AGENDA REPORT

Subject: DISCUSSION OF METRO WESTSIDE SUBWAY EXTENSION DRAFT ENVIRONMENTAL IMPACT STATEMENT/DRAFT ENVIRONMENTAL IMPACT REPORT PROPOSED COMMENT LETTER

**Draft Comment Letter and Attachments on the
DEIS/DEIR**

**Geotechnical Engineering Report
Westside Subway Extension
Review of Draft Environmental Impact Report
Beverly Hills, California**

SHANNON & WILSON, INC.
Geotechnical and Environmental Consultants **FIG. 2**
Sheet 3 of 8

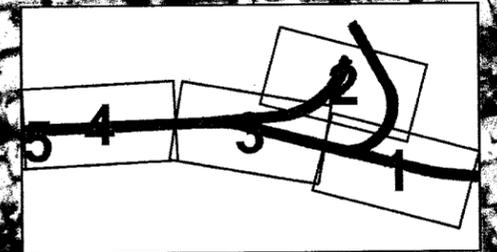
warning systems, plus the operation of traction power substations.” Noise from above ground portions of the stations is a potential impact, but the DEIR concluded the impact is insignificant. Vent shafts are known to generate noise from trains and fans, and are proposed on Wilshire Boulevard between Willaman Drive and Carson Road (Sheet 3 of Figure 2).

Westside Subway Extension Review Beverly Hills, California	
POTENTIALLY ACTIVE FAULT MAP	
October 2010	51-1-10024-001
SHANNON & WILSON, INC. <small>GEOTECHNICAL AND ENVIRONMENTAL CONSULTANTS</small>	FIG. 4

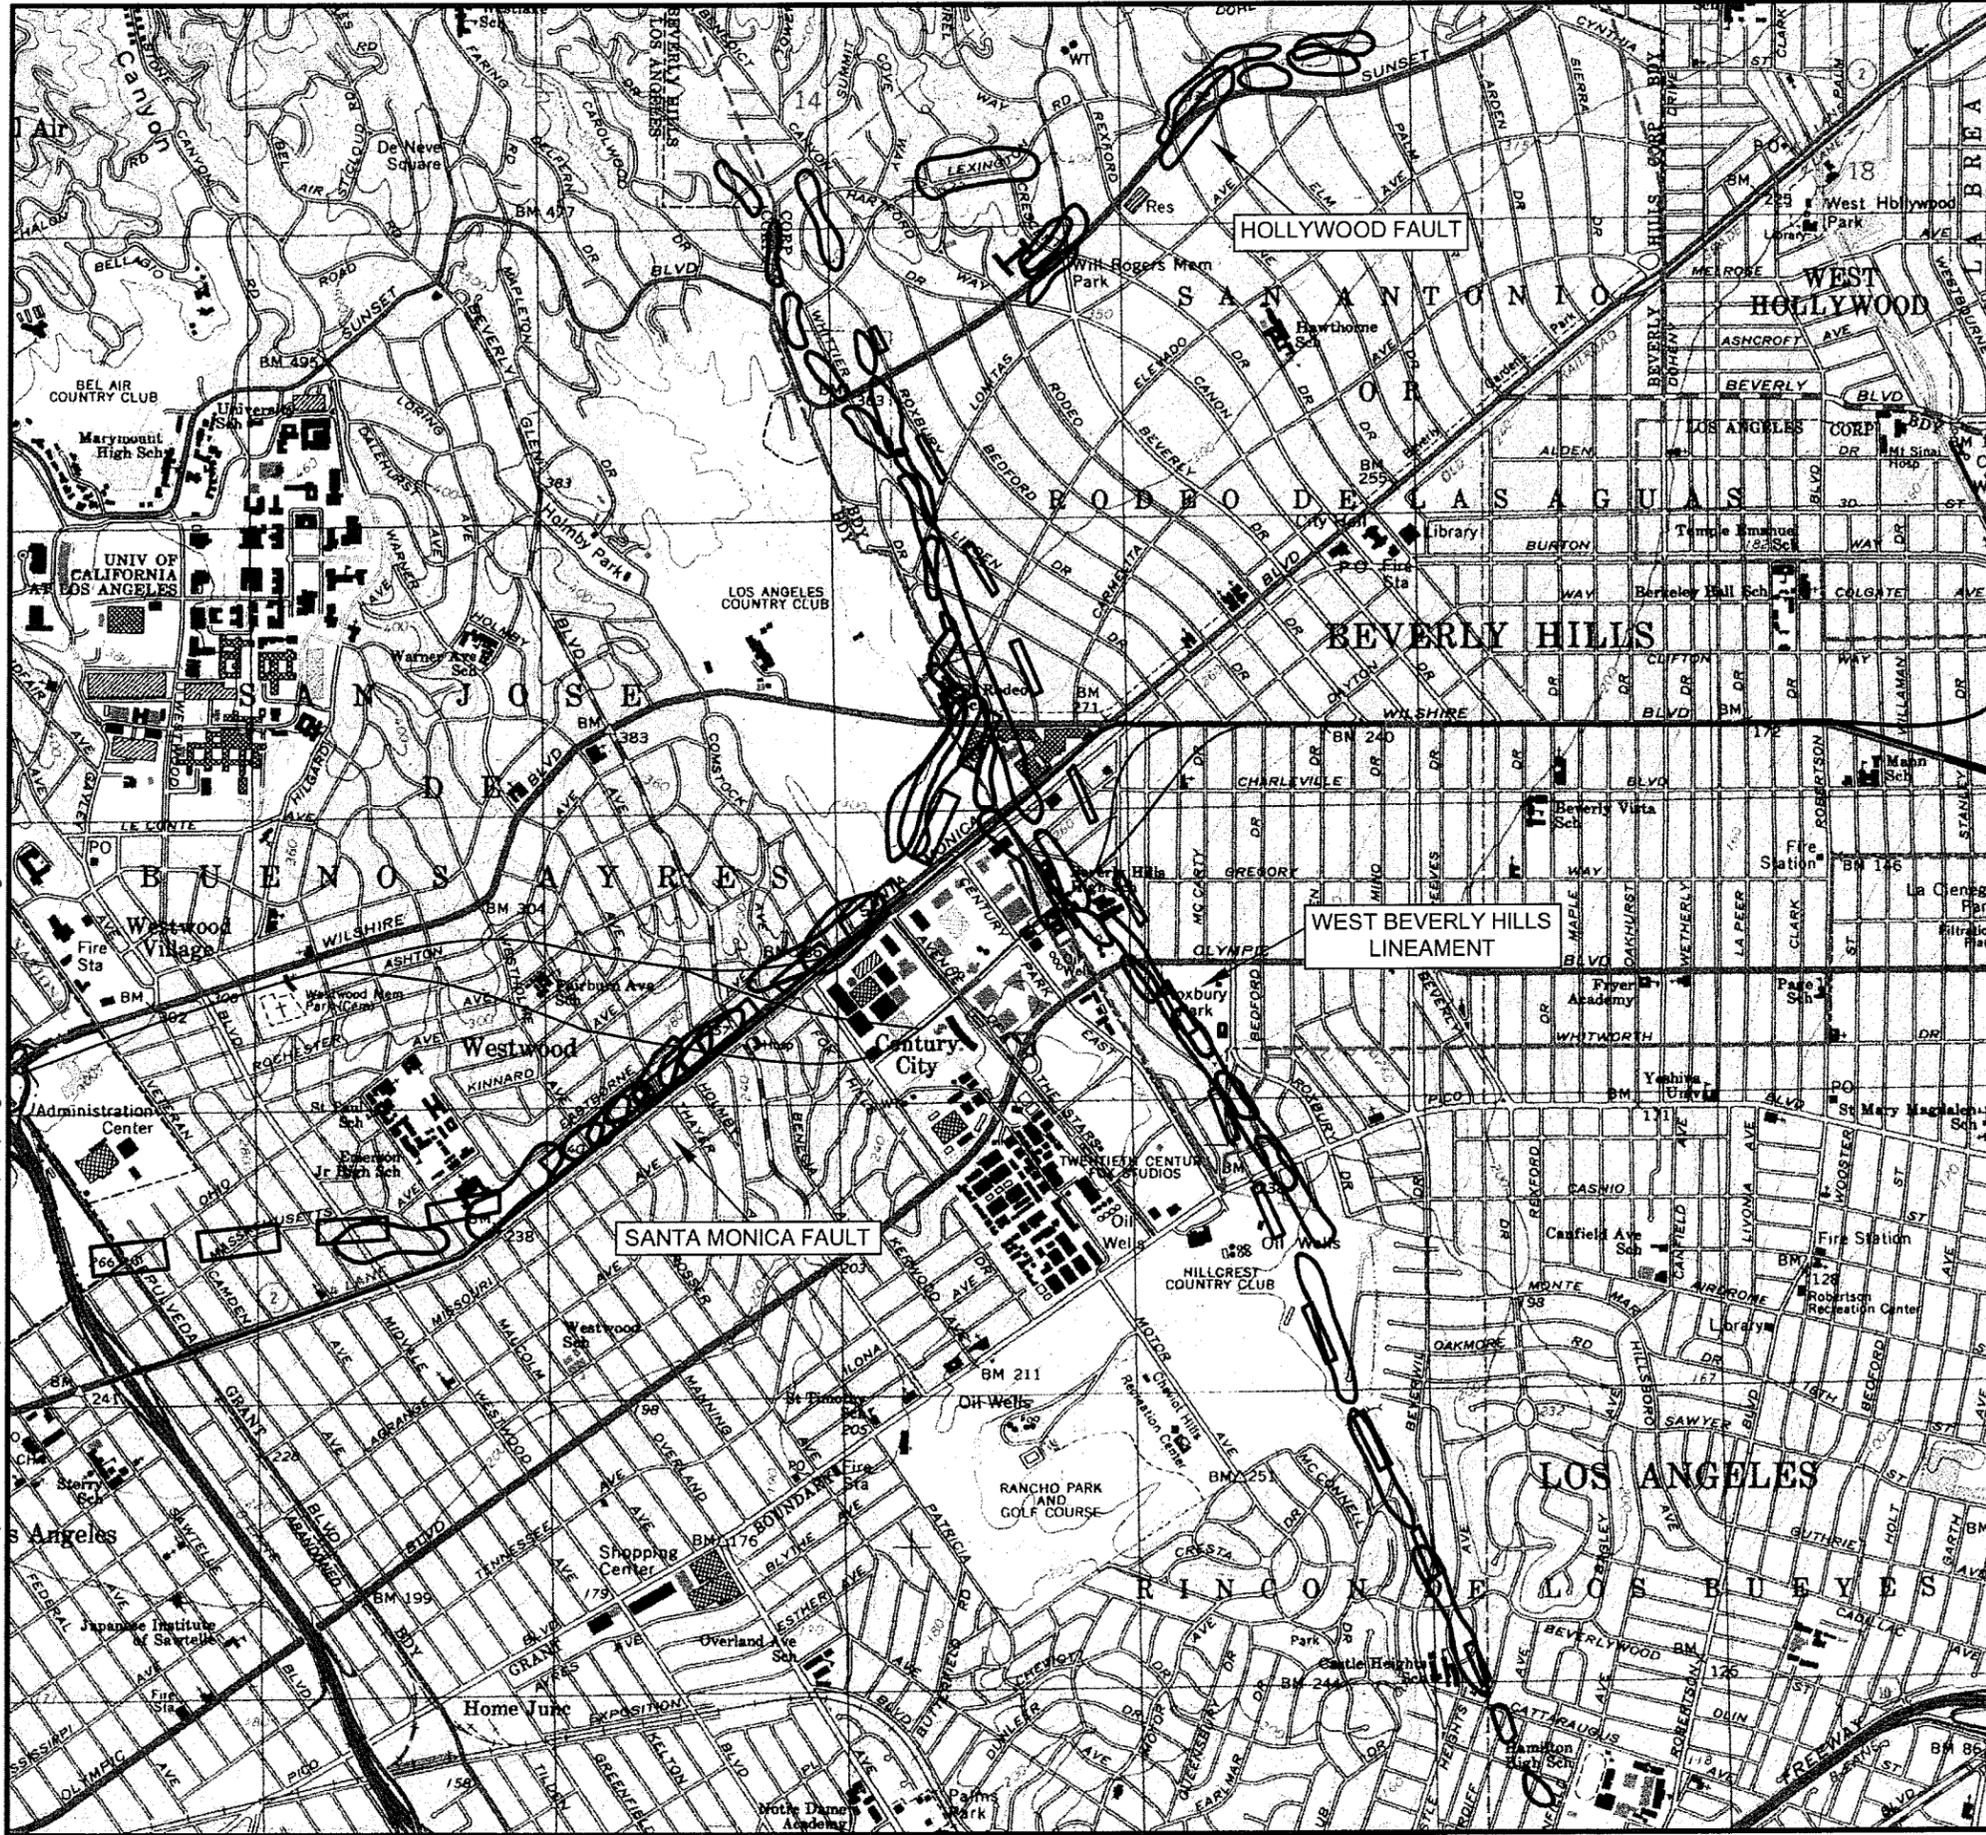
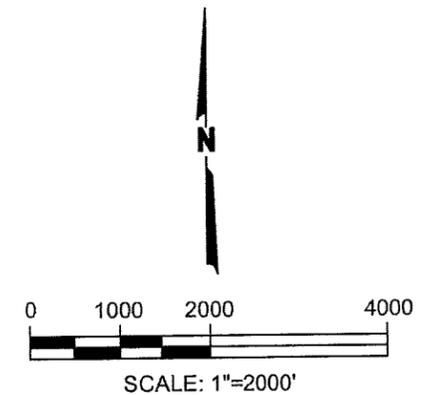
The DEIR Geotechnical Report indicates that the Santa Monica Fault runs approximately along Santa Monica Boulevard from about Avenue of the Stars westward (Figure 4). This report also describes the uncertainty as to the presence, characteristics, and activity of the West Beverly Hills Lineament. The report states that the Santa Monica Fault has not been included in the State of California Alquist-Priolo Special Studies Zone (A-P Zone) due to “the absence of well-defined fault traces.” Further evaluation of both faults (including location, width of fault zone,

FIG. 5

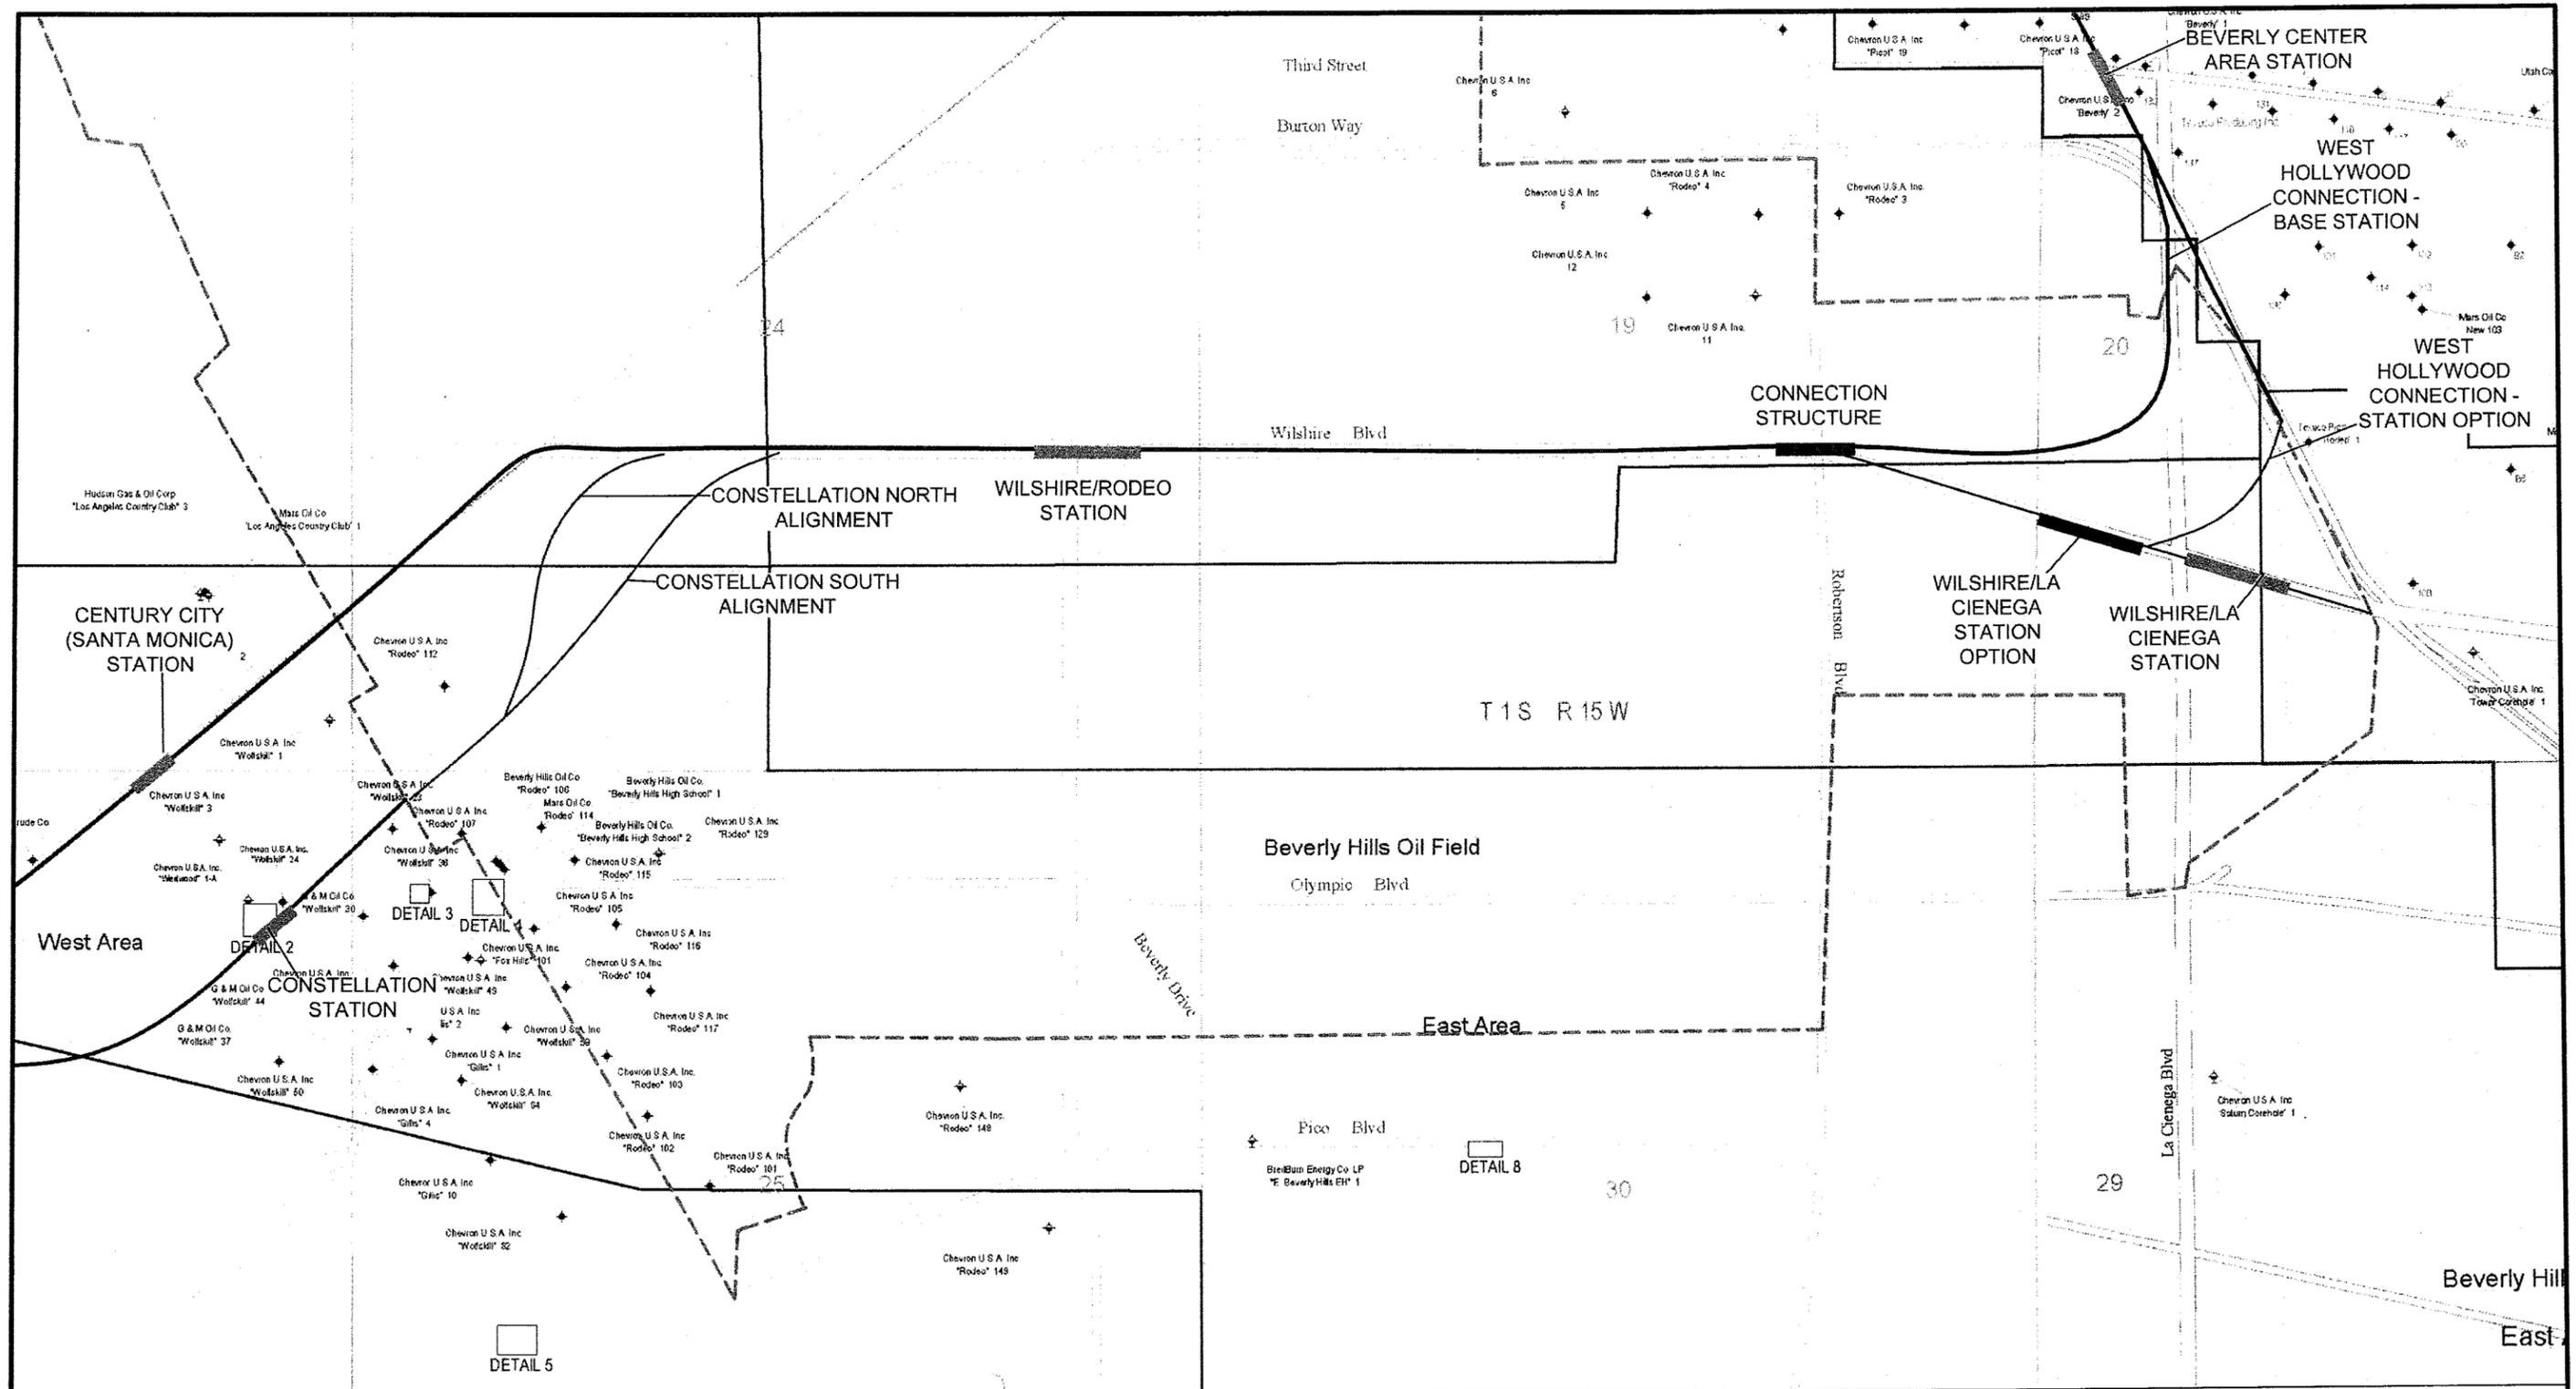
An enlarged portion of the liquefaction map presented in DEIR Chapter 4 (Figure 4-48) is provided for the City portion as Figure 5. The tunnels within the City are proposed to be below potentially liquefiable soils, which the DEIR limits to Holocene-deposited (last 11,000 years) soil. However, liquefaction could impact the upper walls at the Wilshire/La Cienega base and option stations. The DEIR Geotechnical Report notes that “cohesionless granular sediment” in the upper 30 feet is most susceptible to liquefaction, but liquefaction is possible to 50 feet below the ground surface. The report states that “...tunnels will be driven below the potentially liquefiable Holocene section and into the underlying Pleistocene alluvium and Pleistocene Lakewood and San Pedro Formation sediments...” Settlement of stations from liquefaction is also unlikely given their depth (same as the tunnels), and because the alignment traverses relatively level terrain, lateral spreading is also not considered an impact. Also, the DEIR Geotechnical Report notes that the potential for liquefaction during station construction is “considered extremely remote.”
